Re: GMP Submittal
Project: Hamilton High School Gutter Replacement
Jasper, FL

Hamilton High School Gutter Replacement Project

Guaranteed Maximum Price (GMP)

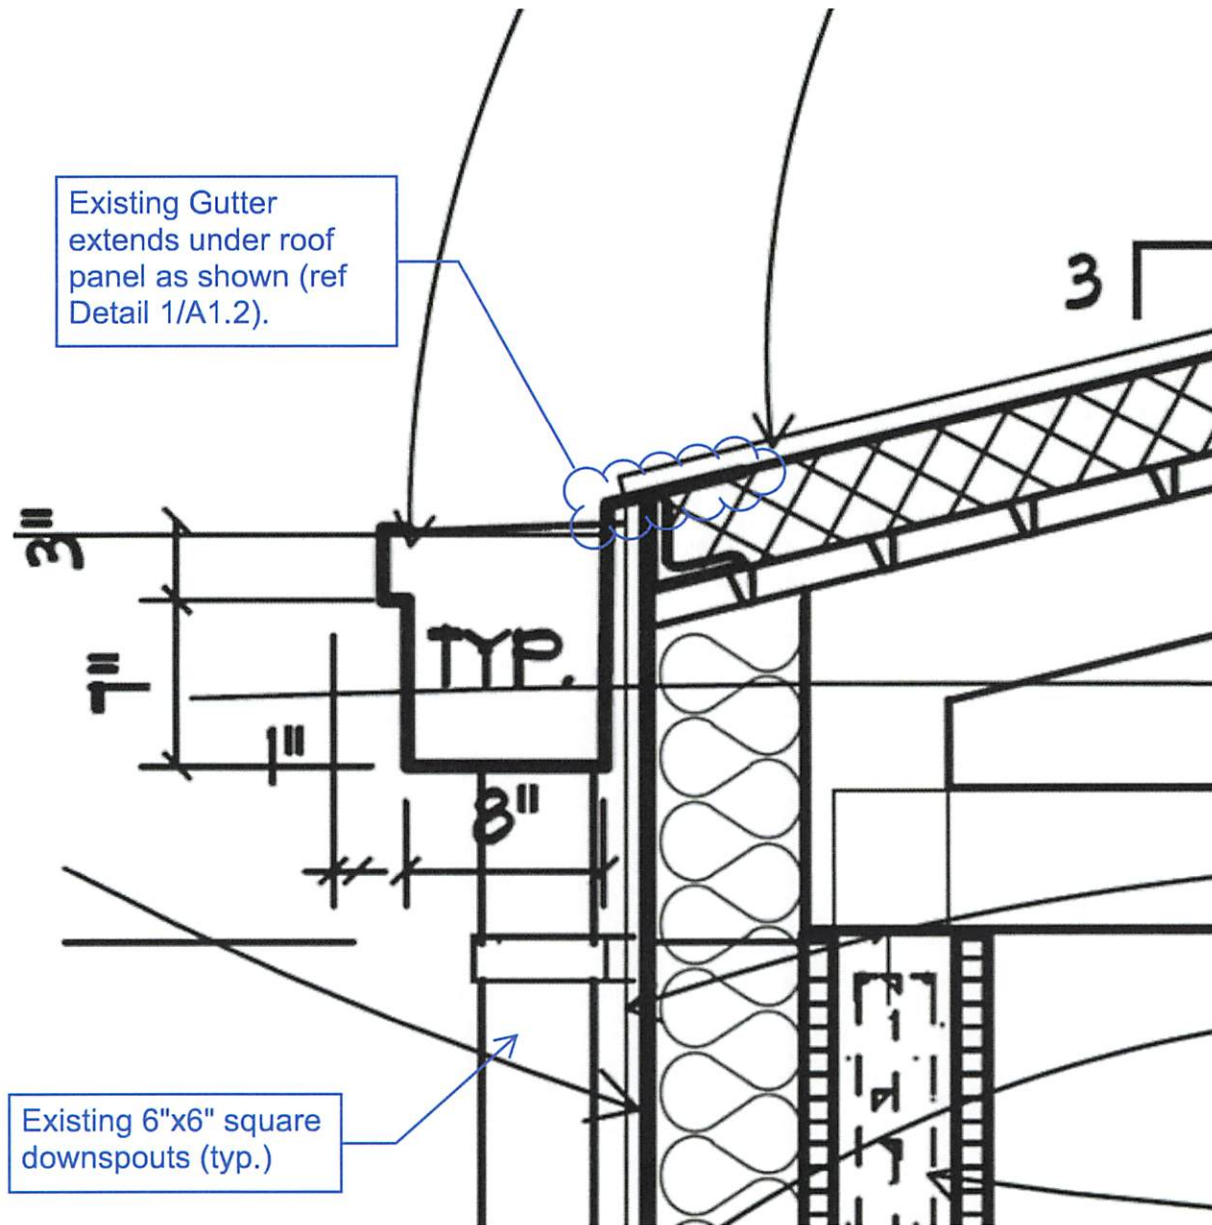
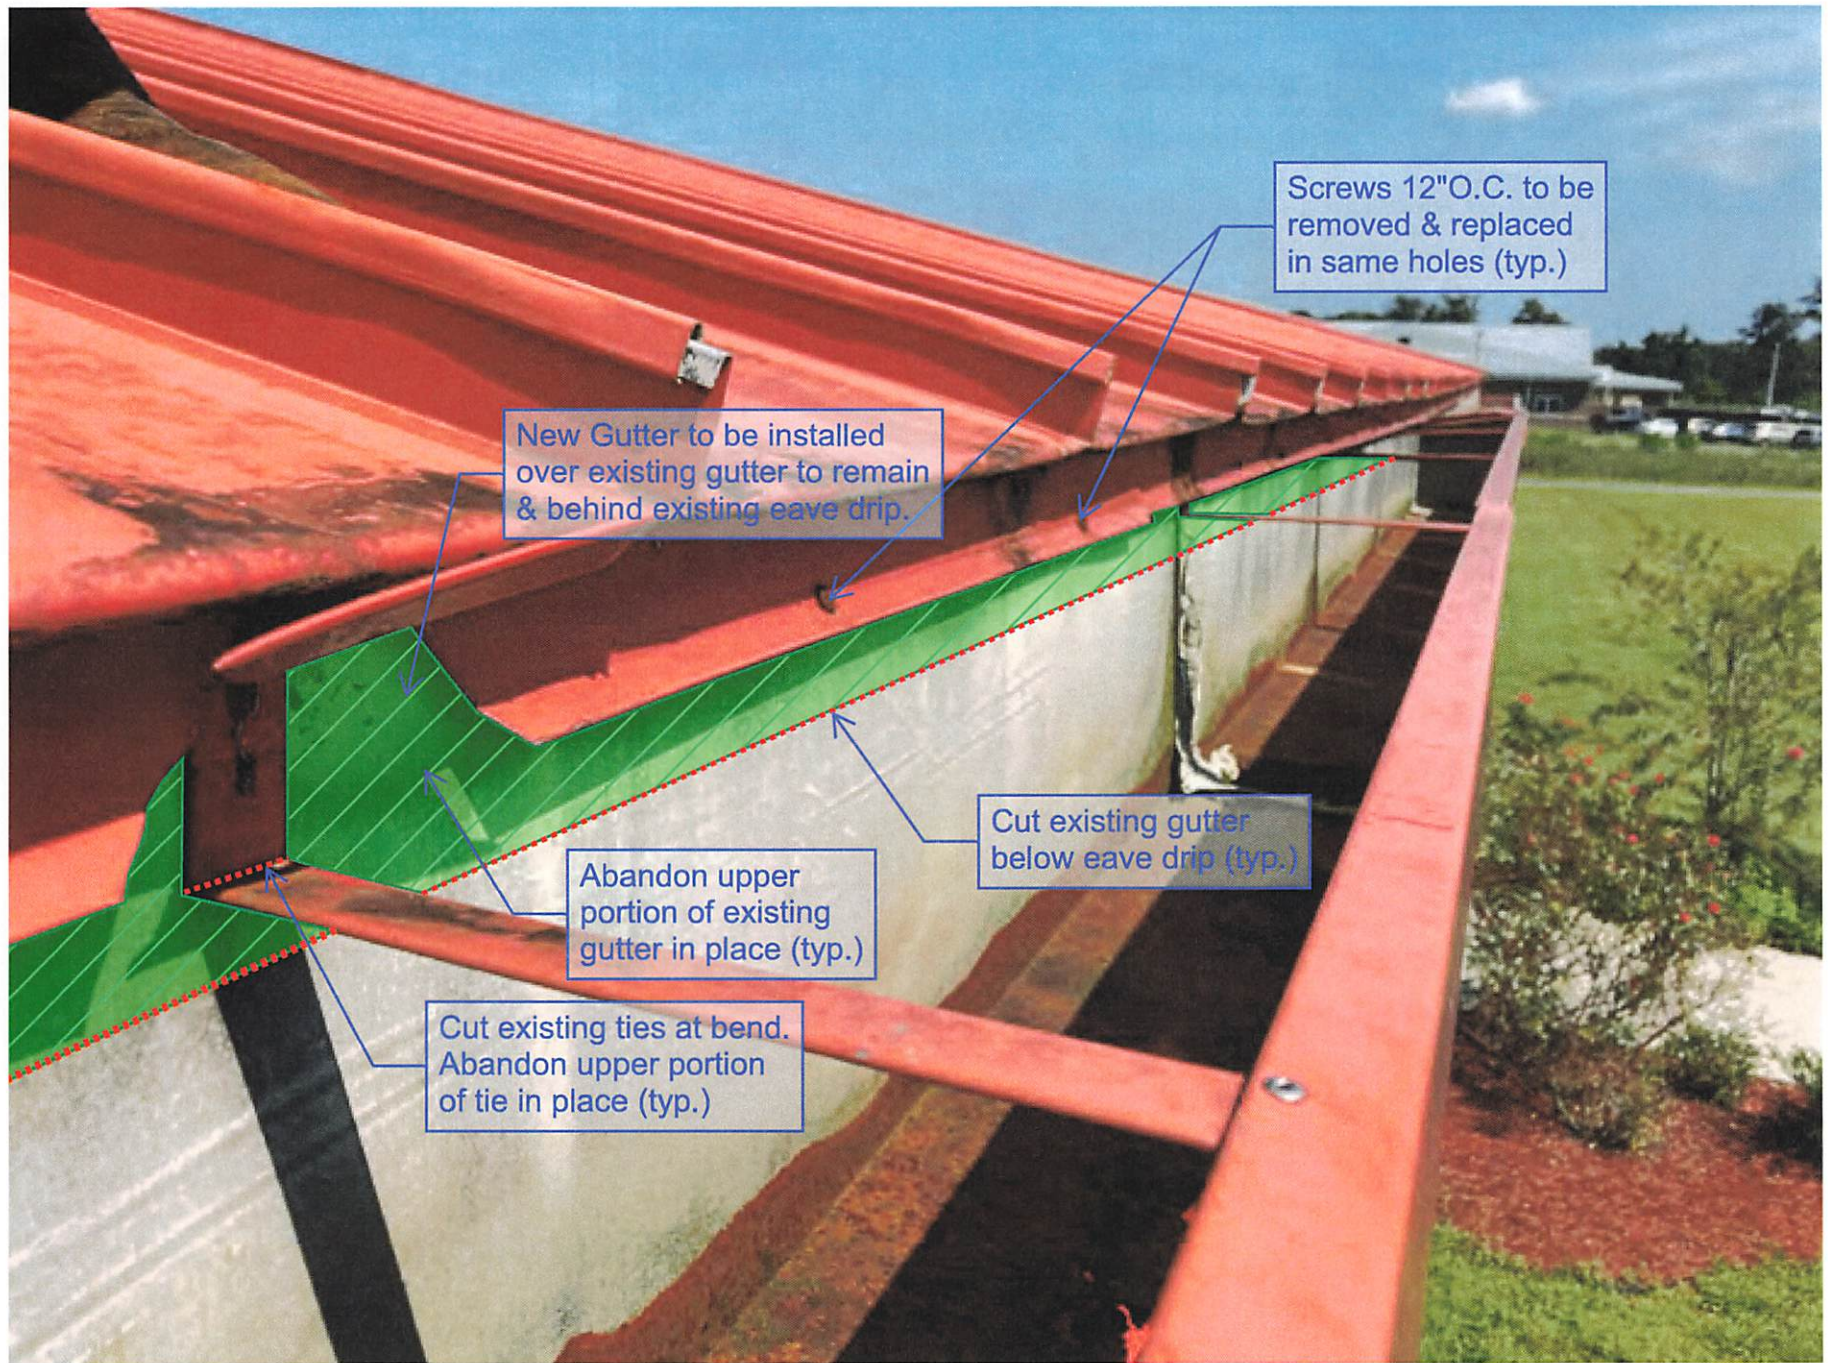
- Existing gutter extends under the roof panel. An as built detail will be marked up to illustrate the installation.
 - Existing gutter will have to be cut below the existing eave drip using a tool that will not deform the material and not cause a fire.

- New gutter will fit behind the eave drip and the abandoned existing gutter metal.
 - All screws removed will be reinstalled through the existing holes in the eave drip. The screws appear to be 12" OC.

- New gutter and downspout will match existing. Contractor to field verify, the gutter is 8" wide x 10" deep; the downspouts are 6" x 6".

5. ☐ Gutters 8" wide by 10" deep and square 6" x 6" downspouts matching the existing (See sketches Z1.0 and Z2.0 for information, typ.).
6. ☐ Furnish and install downspout adapters that connect the downspouts to the existing underground storm drain piping.
 - ☐ Underground storm drain piping is existing. Replace all adapters with new. Exclude adapters cast in the concrete sidewalks.
 - ☐ Trim above-grade portion of the underground storm drain piping to accommodate the new downspout adapter if required.
7. ☐ Provide new concrete splash blocks where downspouts are not connected to underground storm drain piping.

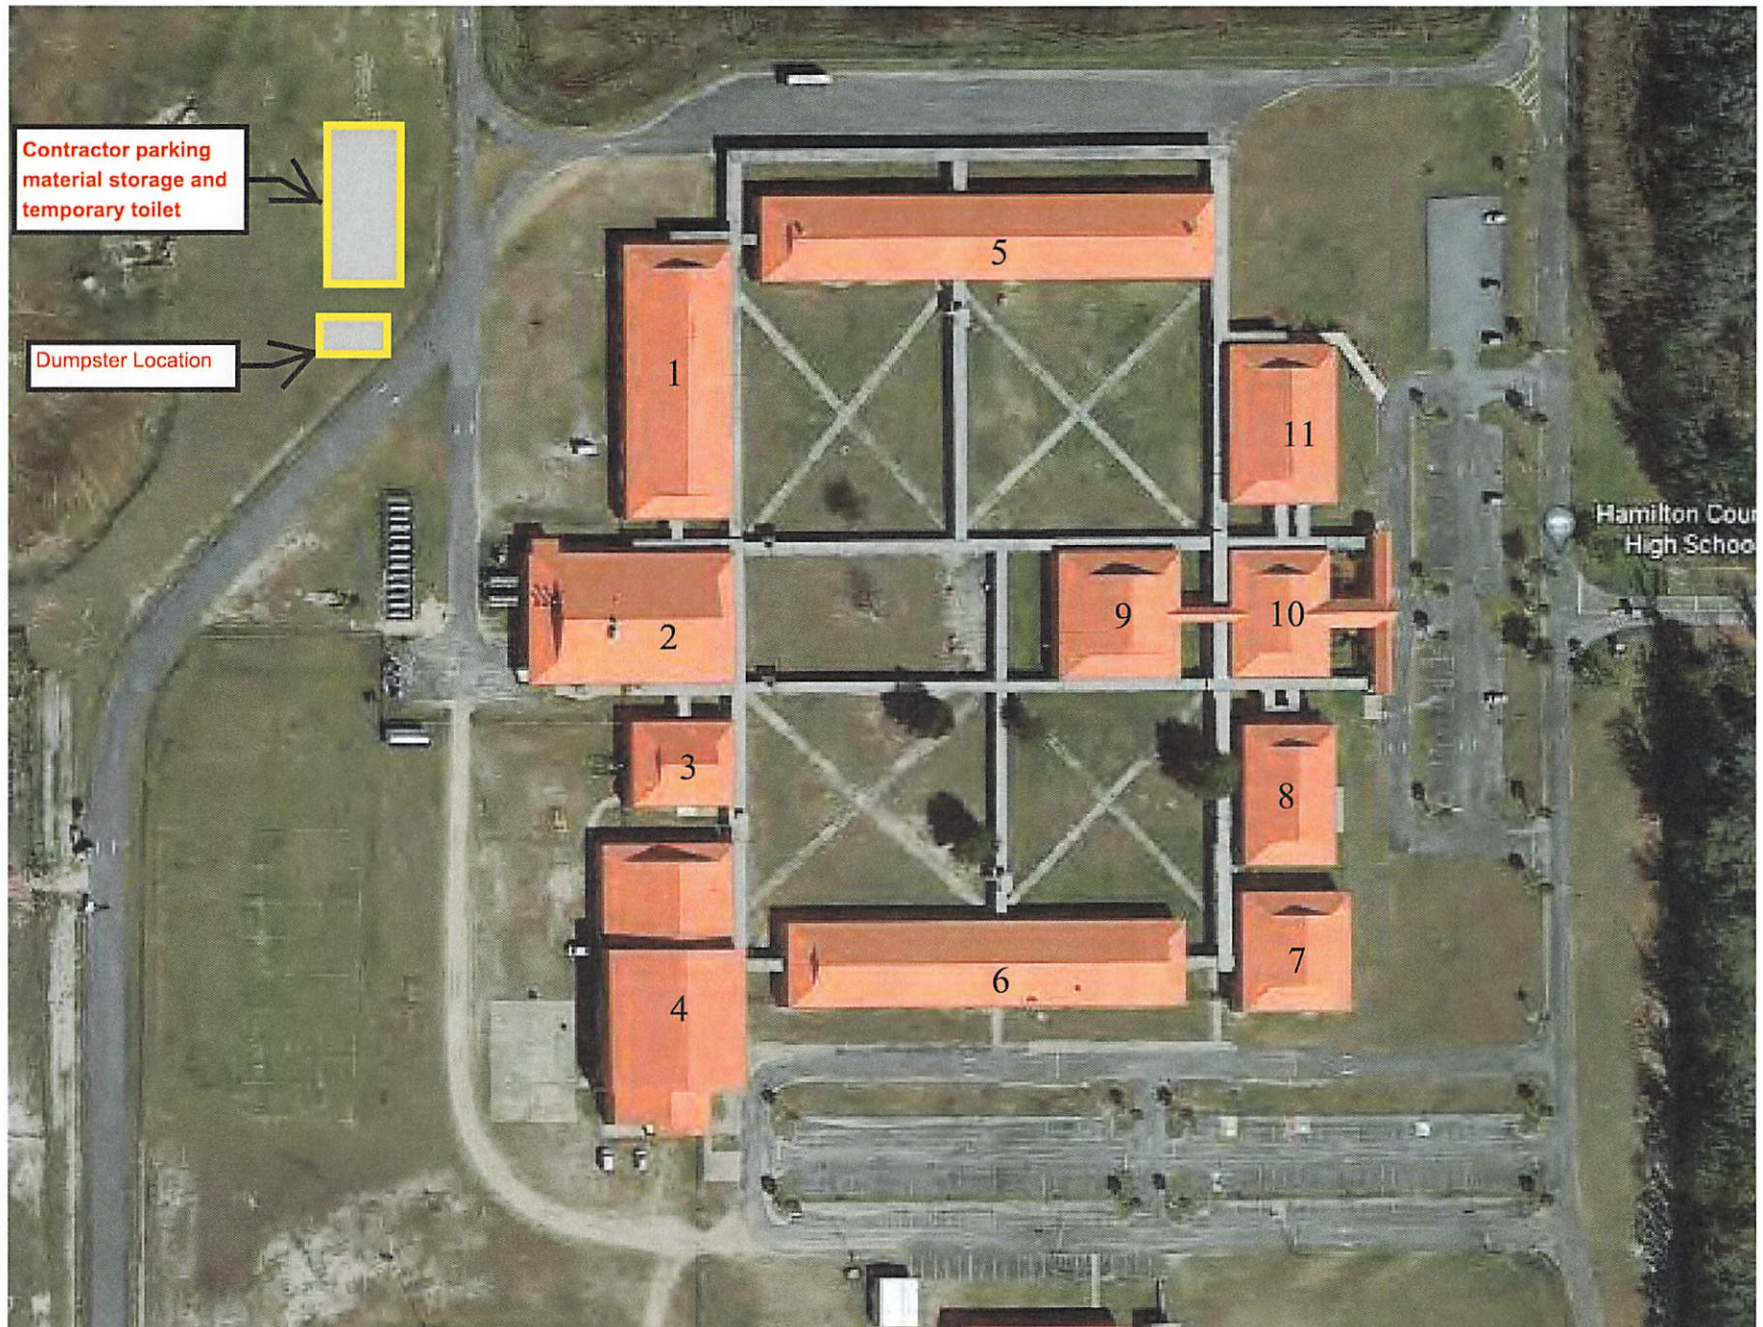
5. ☐ Gutters 8" wide by 10" deep and square 6" x 6" downspouts matching the existing (See sketches Z1.0 and Z2.0 for information, typ.).
6. ☐ Furnish and install downspout adapters that connect the downspouts to the existing underground storm drain piping.
 - ☐ Underground storm drain piping is existing. Replace all adapters with new. Exclude adapters cast in the concrete sidewalks.
 - ☐ Trim above-grade portion of the underground storm drain piping to accommodate the new downspout adapter if required.
7. ☐ Provide new concrete splash blocks where downspouts are not connected to underground storm drain piping.
